Project Number 192-01-03

**Subject: Revisions to Work Plan for Environmental Site Assessment at
Foothill Beacon, 16210 Foothill Blvd, San Leandro, California**

Attachment: Figure 2 - Site Plan, Proposed Well Locations (Revised 3/25/98)

Proposed Well Locations
Foothill Beacon
16210 Foothill Boulevard
San Leandro, CA

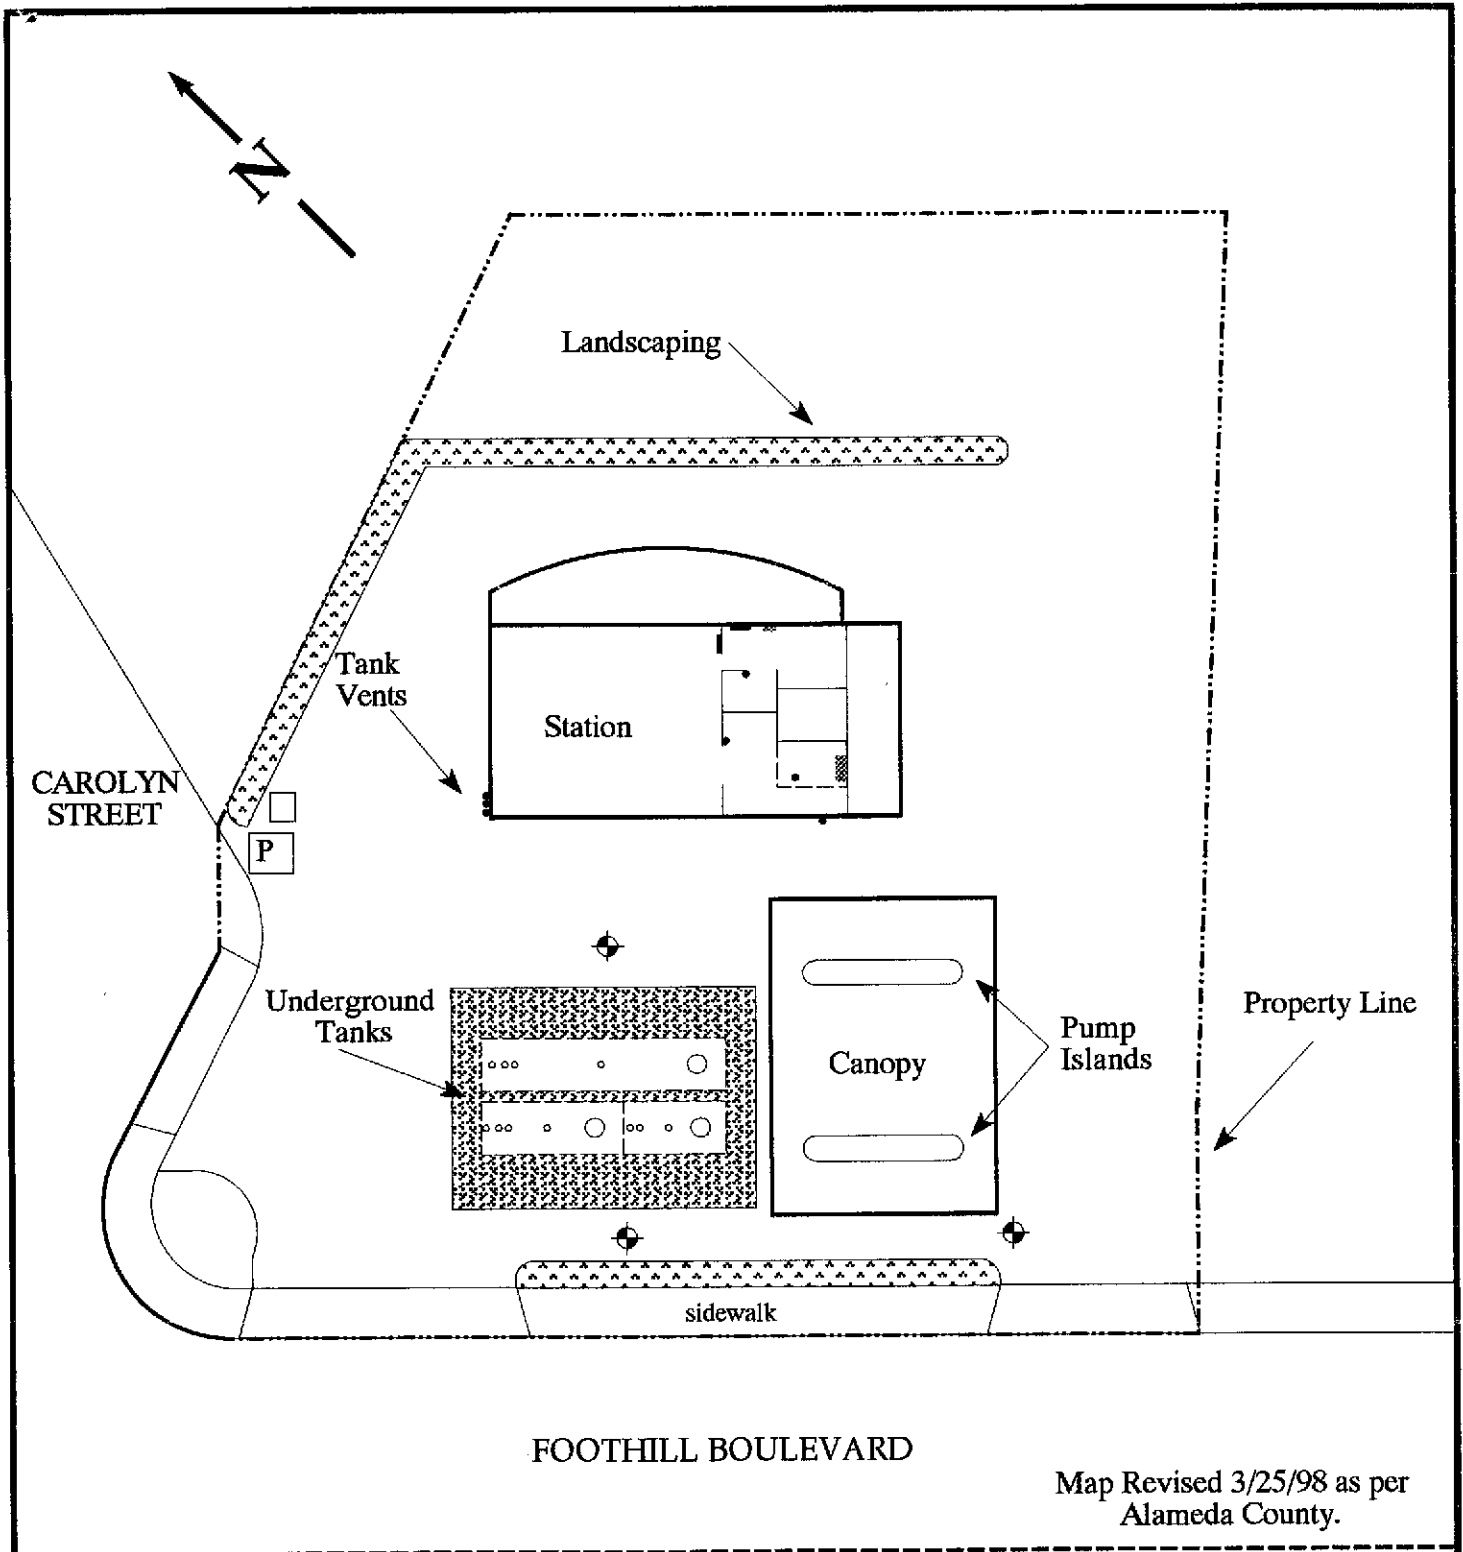
The first revision is to the proposed well locations on Figure 2. Based on your experience with monitoring wells nearby, the groundwater gradient is toward the southwest. One proposed well has been moved to take advantage of this information, and is show on the attached revised Figure 2.
